SUBJECT: COMANCHE PEAK STEAM ELECTRIC STATION (CPSES) - UNIT 2
 DOCKET NO. 50-446
 PRESSURIZER SURGE LINE LEAK-BEFORE-BREAK ANALYSIS

REF: NRC letter dated July 10, 1992, to William J. Cahill, Jr.,
 "Request for Additional Information - Comanche Peak
 Steam Electric Station Unit 2, Pressurizer Surge Line
 Leak-Before-Break Analysis (TAC No. M82947)"

RESPONSES TO NRC "REQUEST FOR ADDITIONAL INFORMATION -
CPSES, UNIT 2, PRESSURIZER SURGE LINE LEAK-BEFORE-
BREAK ANALYSIS." NRC LETTER OF JULY 10, 1992

FIGURE 1

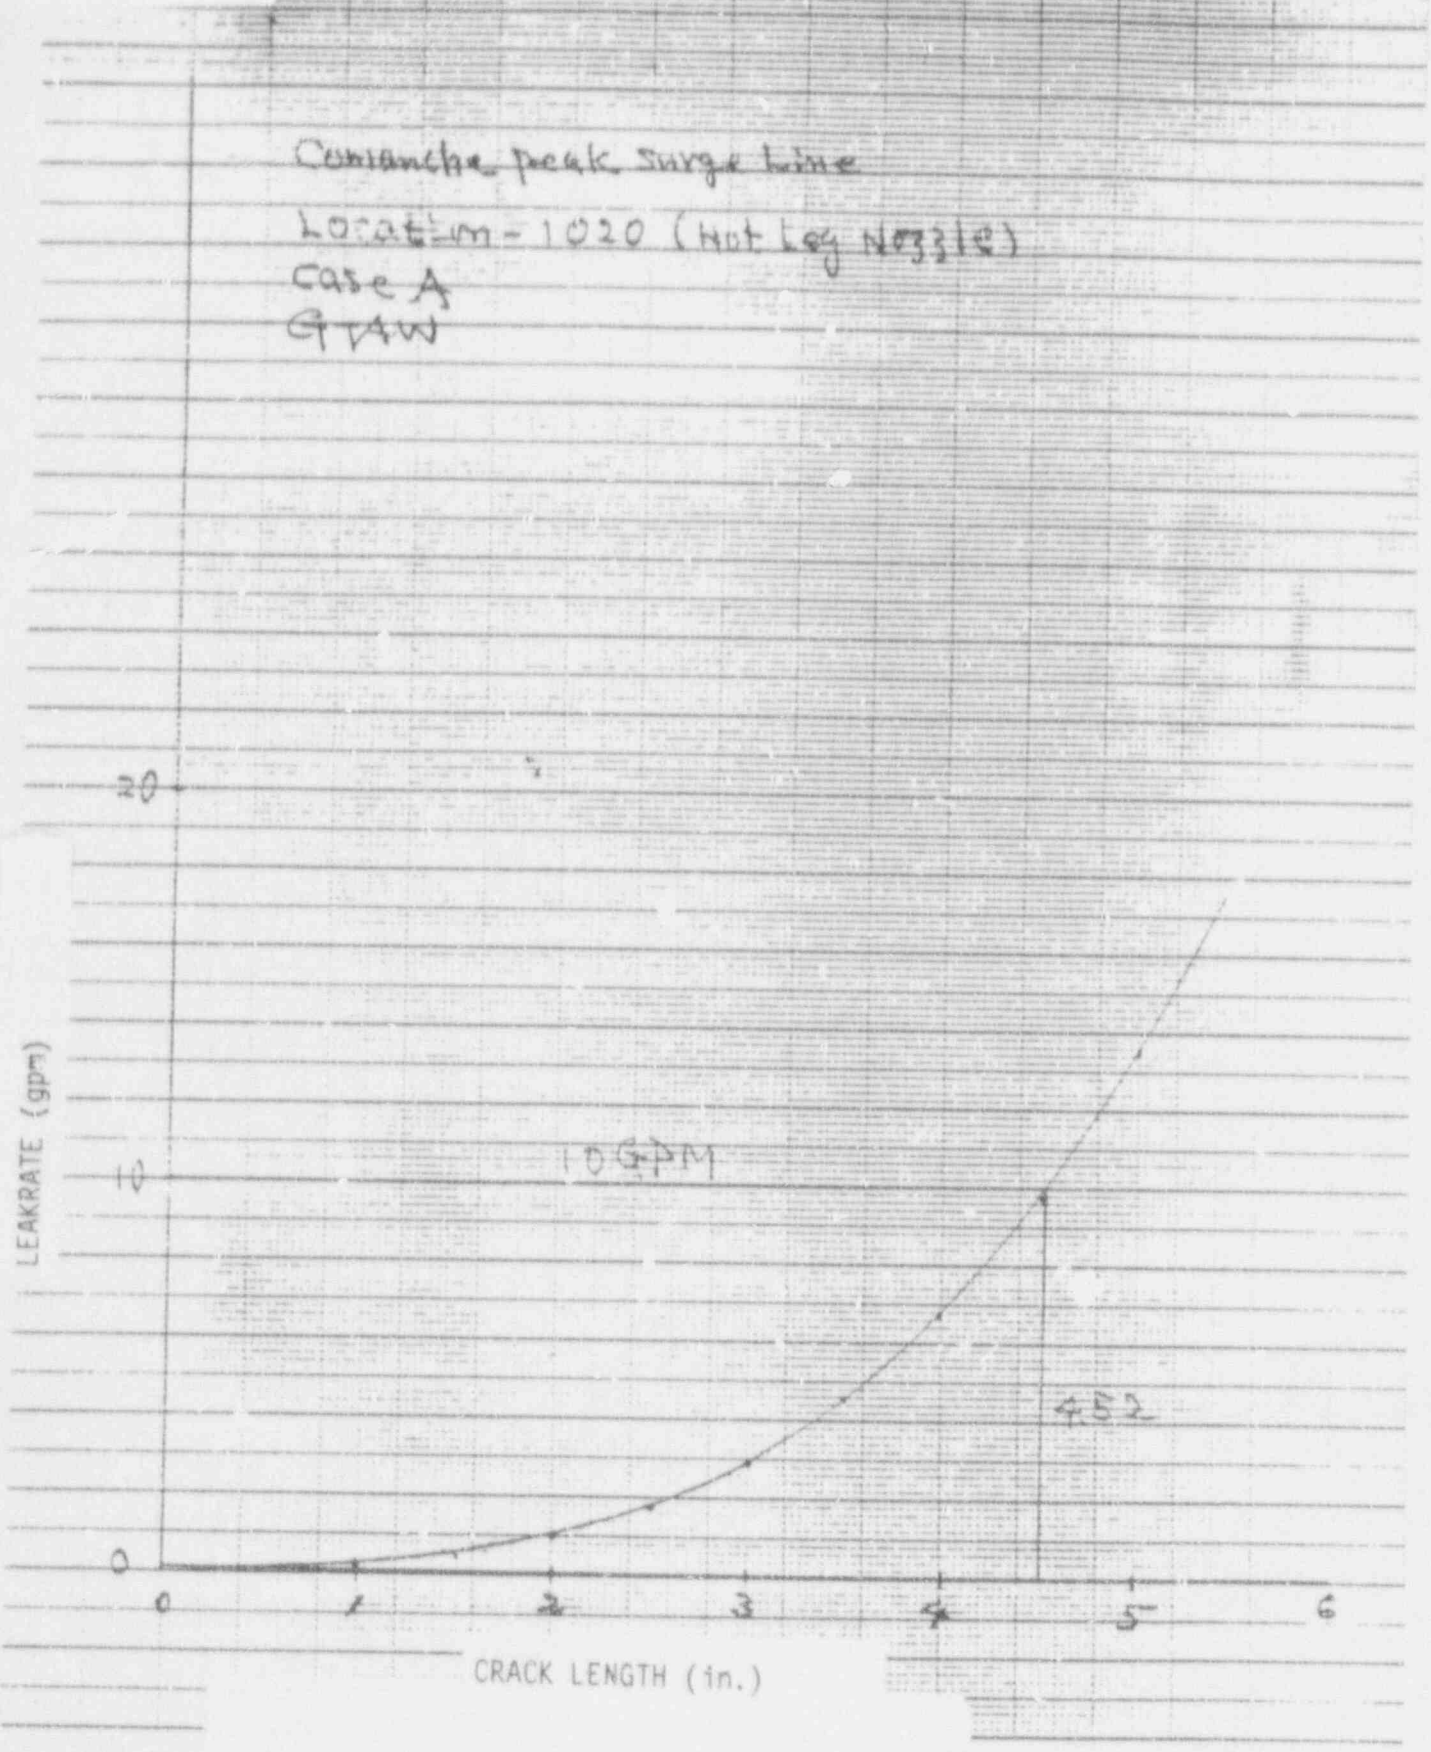
Supply a copy of actual data input to the computer program and the corresponding computer output for limit load analysis and leakage flow size calculation for Case B/G of Table 7-1.

Leakage flow size, as reported in Table 5-1 and subsequently carried over to Table 7-1, is determined from "Leak Rate vs. Crack Length" graphs. A graph is developed for the governing location (node 1020) for each of the three normal, stratification, and heat-up/cool-down load cases, which are defined in Table 4-2 of WCAP-13100, and labeled as Load Cases A, B, and C.

The graphs used to determine crack length in Table 5-1 for Load Cases A, B, and C are attached as Figures 1, 2 and 3, respectively. As can be seen from the graphs, a leak rate of 10 GPM is conservatively selected from which the applicable crack length is determined. The crack lengths found which would produce a 10 GPM leak rate are 4.52 inches for Case A, 3.70 inches for Case B, and 2.50 inches for Case C.
